NEW SANCTUARY FOR  
ST. ELIZABETH CPCA  
104 PERRY ST.  
MADISON, ALABAMA 35758

- 3/16/18: ADDED A2.1 AND A2.2 DUE TO ADDING CONNECTOR ADDITIVE ALTERNATE  
A2.1 PLAN PART A (WITH CONNECTOR OPTION) 1/4"=1'-0"  
A2.2 PLAN PART B (WITH CONNECTOR OPTION) 1/4"=1'-0"  
A3 PLAN OF SANCTUARY ADDITION WITH ROOM, DOOR AND WINDOW MARKS  
A4 MEZZANINE FLOOR PLAN AND SCHEULES/NOTES  
A5 SOUTH AND EAST ELEVATIONS  
A6 NORTH AND WEST ELEVATIONS  
A7 ROOF PLAN  
LS1 LIFE SAFETY PLAN  
L1 LANDSCAPE PLAN

12/24/17: CONNECTOR OPTION WAS ADDED TO CONNECT EXISTING BUILDING AND SANCTUARY ADDITION.  
3/16/18: CONNECTOR OPTION WAS REVISED TO INCLUDE AN INTERIOR RAMP AND SOUTH EXTERIOR DOOR WAS DELETED.

EXISTING AND SANCTUARY ADDITION FLOOR PLAN  
WITH ADDITIVE ALTERNATE CONNECTOR SHOWN

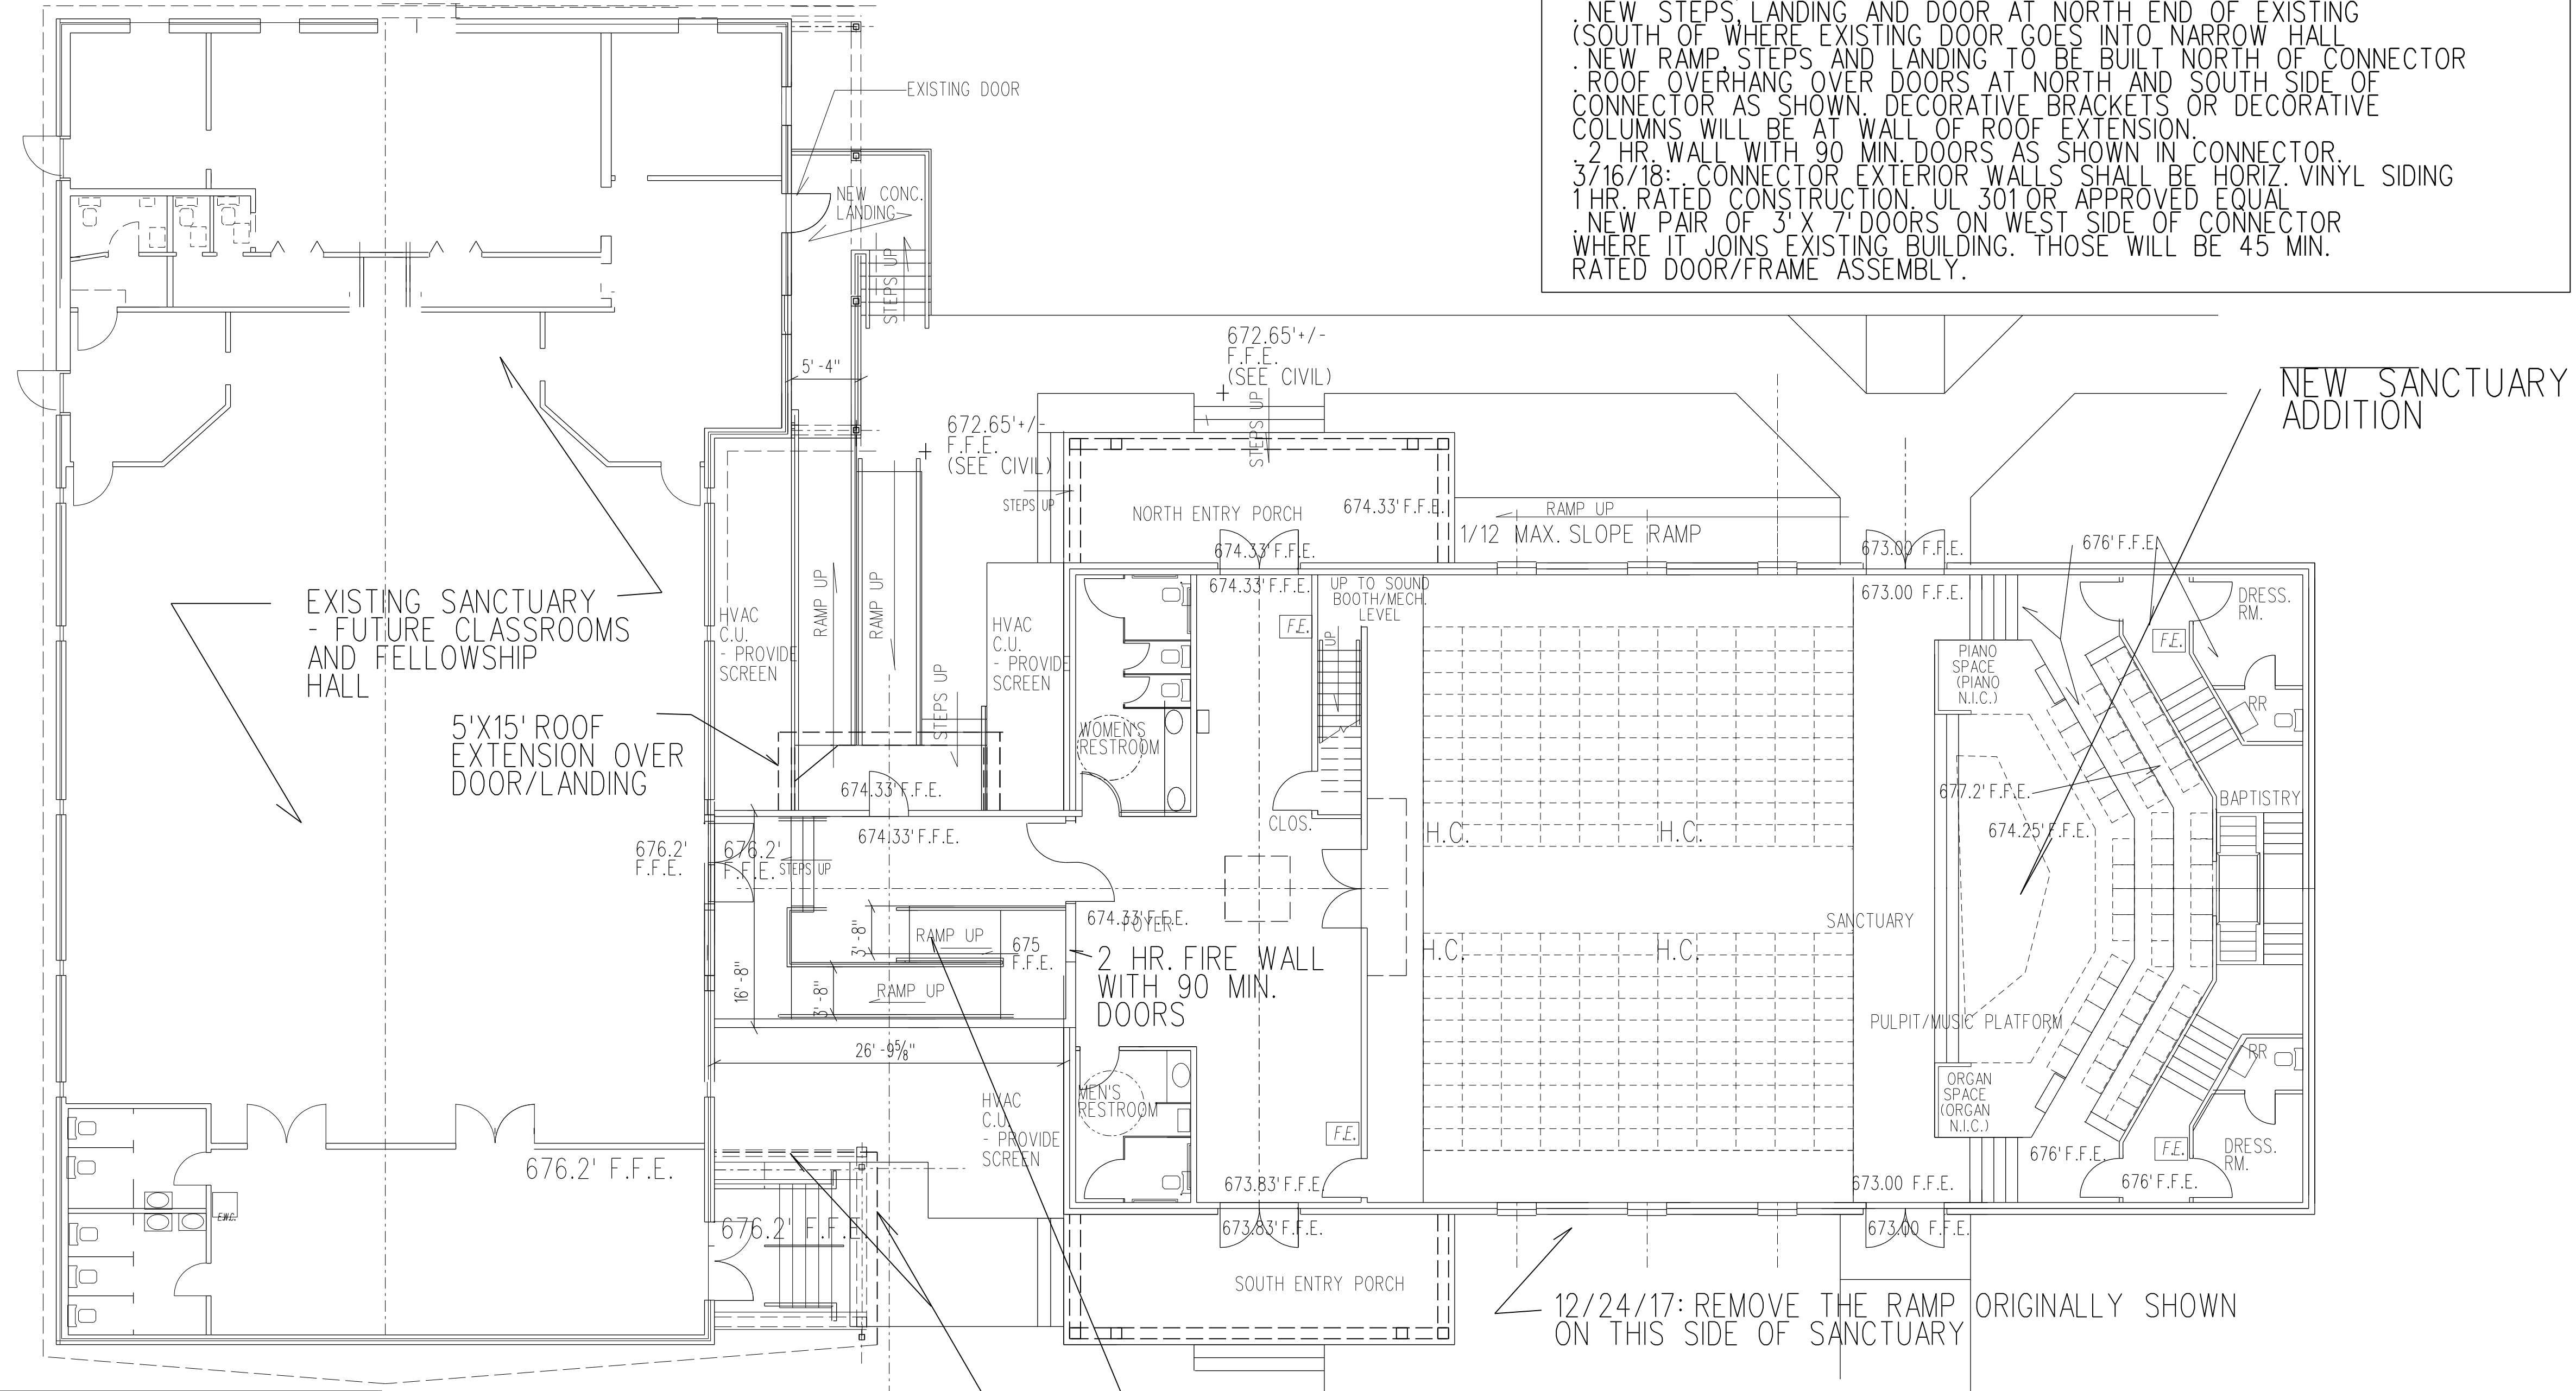
12/24/17: NOTES FOR CONNECTOR ADDITIVE ALTERNATE  
(INVOLVES EXISTING PORCHES, STEPS, LANDING, BRICK WALLS):  
EXISTING PORCHES ON EAST SIDE TO BE REMOVED BACK  
TO 6'-6" ON NORTH END AND ABOUT 11' ON SOUTH END (SOUTH  
END TO BE TAKEN BACK TO COLUMN LINE IN THE MIDDLE OF  
EXISTING LARGE PORCH). WIDTH OF PORCHES SHALL BE  
MODIFIED TO FIT OVER WIDTH OF LANDINGS AT DOORS.  
(SEE PLANS)  
EXISTING H.C. RAMP TO BE REMOVED (EAST OF EXIST. SANCTUARY)  
EXISTING STEPS, LANDING, BRICK WALL AT NORTH  
END ON EAST SIDE TO BE REMOVED  
EXISTING STEPS ON SOUTH END ON EAST SIDE TO  
REMAIN AND RAILING ON NORTH END TO BE INSTALLED  
WHERE RAMP IS REMOVED.  
3/16/18: ALL RAILINGS SHALL MEET IBC  
AND ADA REQUIREMENTS.  
NEW STEPS, LANDING AND DOOR AT NORTH END OF EXISTING  
(SOUTH OF WHERE EXISTING DOOR GOES INTO NARROW HALL)  
NEW RAMP STEPS AND LANDING TO BE BUILT NORTH OF CONNECTOR  
ROOF OVERHANG OVER DOORS AT NORTH AND SOUTH SIDE OF

CONNECTOR AS SHOWN. DECORATIVE BRACKETS OR DECORATIVE  
COLUMNS WILL BE AT WALL OF ROOF EXTENSION.  
2 HR. WALL WITH 90 MIN. DOORS AS SHOWN IN CONNECTOR.  
3/16/18: CONNECTOR EXTERIOR WALLS SHALL BE HORIZ. VINYL SIDING  
1 HR. RATED CONSTRUCTION, UL 301 OR APPROVED EQUAL  
NEW PAIR OF 3' X 7' DOORS ON WEST SIDE OF CONNECTOR  
WHERE IT JOINS EXISTING BUILDING. THOSE WILL BE 45 MIN.  
RATED DOOR/FRAME ASSEMBLY.

3/16/18: EXTEND ROOF OF  
CONNECTOR DOWN  
OVER DOOR ON NORTH  
SIDE OF CONNECTOR. ROOF  
SHOULD EXTEND OUT  
5' FROM BUILDING SHALL BE SUPPORTED  
WITH DECORATIVE BRACKETS OR  
DECORATIVE COLUMNS.  
EAVE OF CONNECTOR SHALL BE EVEN  
WITH ROOF EAVE OF EXISTING

EXISTING ROOF AT THESE  
EXISTING DOUBLE DOORS  
SHALL BE CUT DOWN TO  
SIZE SHOWN. SEE STRUCTURAL.  
FIELD VERIFICATION BY  
STRUCTURAL ENGINEER  
AFTER ROOF STRUCTURE  
IS REVELED WILL HAVE TO BE DONE.  
TO CONFIRM WHAT NEEDS  
TO BE DONE FOR SMALLER  
ROOF STRUCTURE DESIRED.

PLAN PART B (WITH CONNECTOR OPTION)

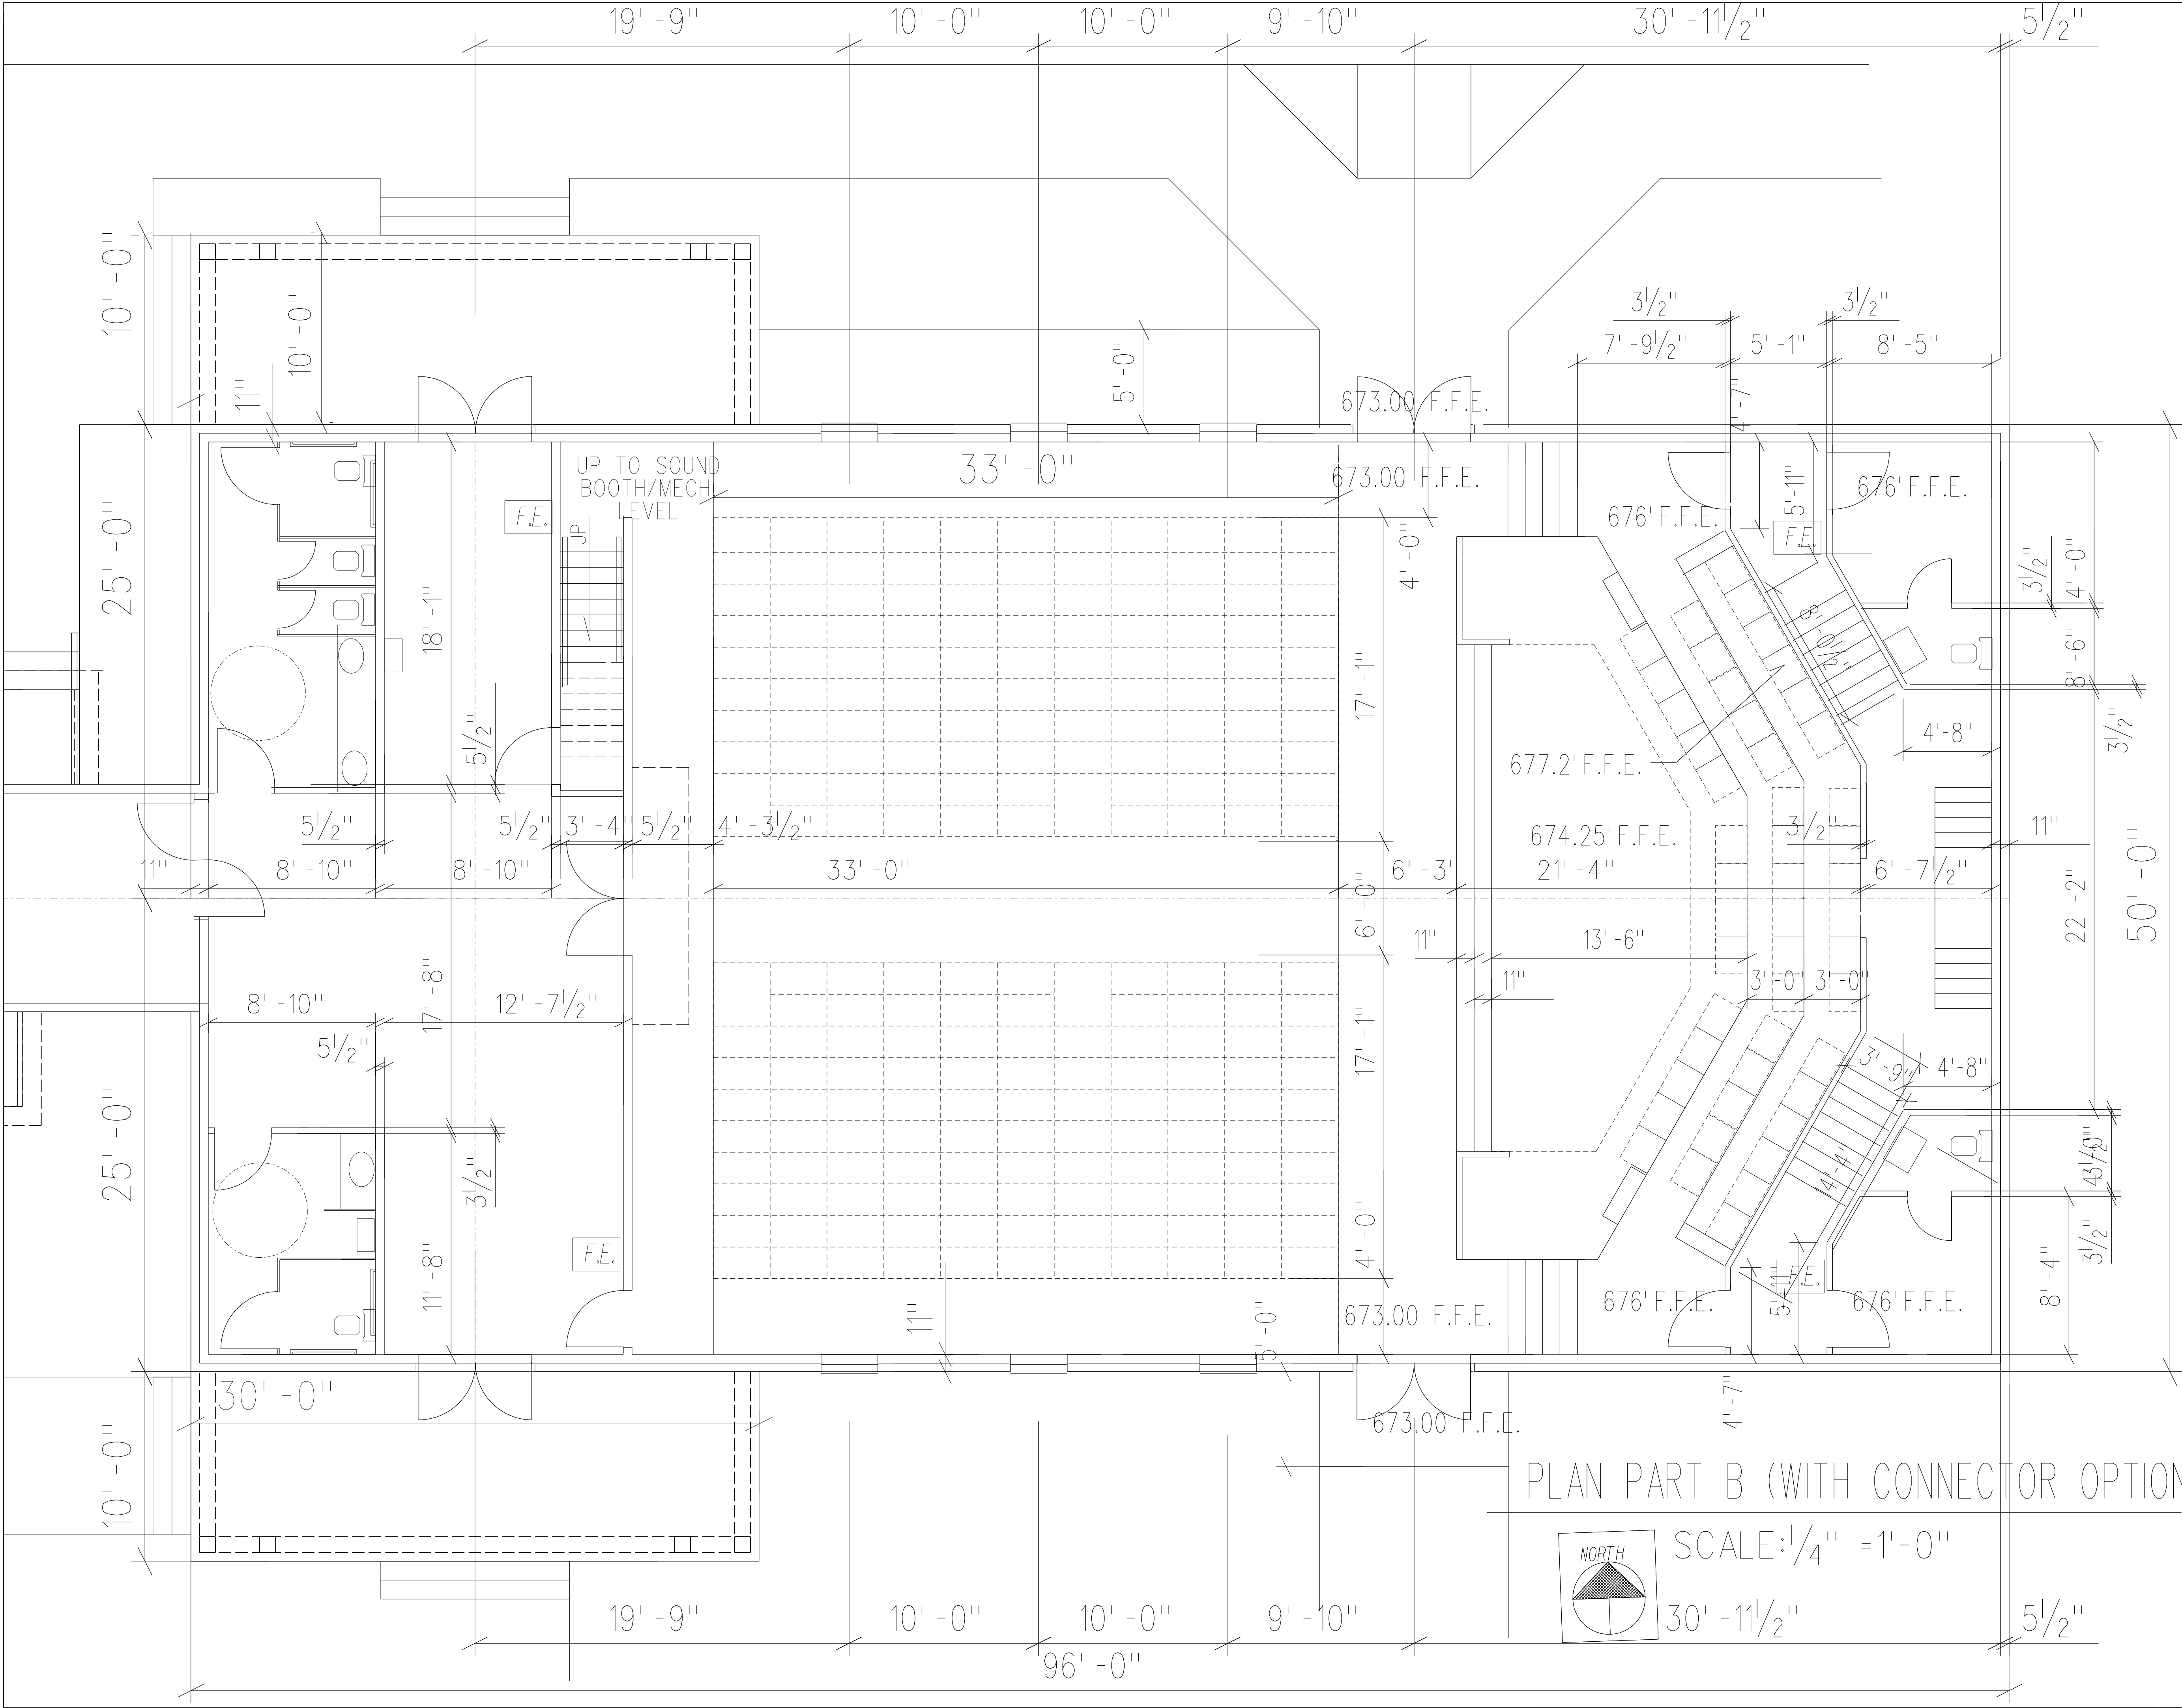
31618: revised
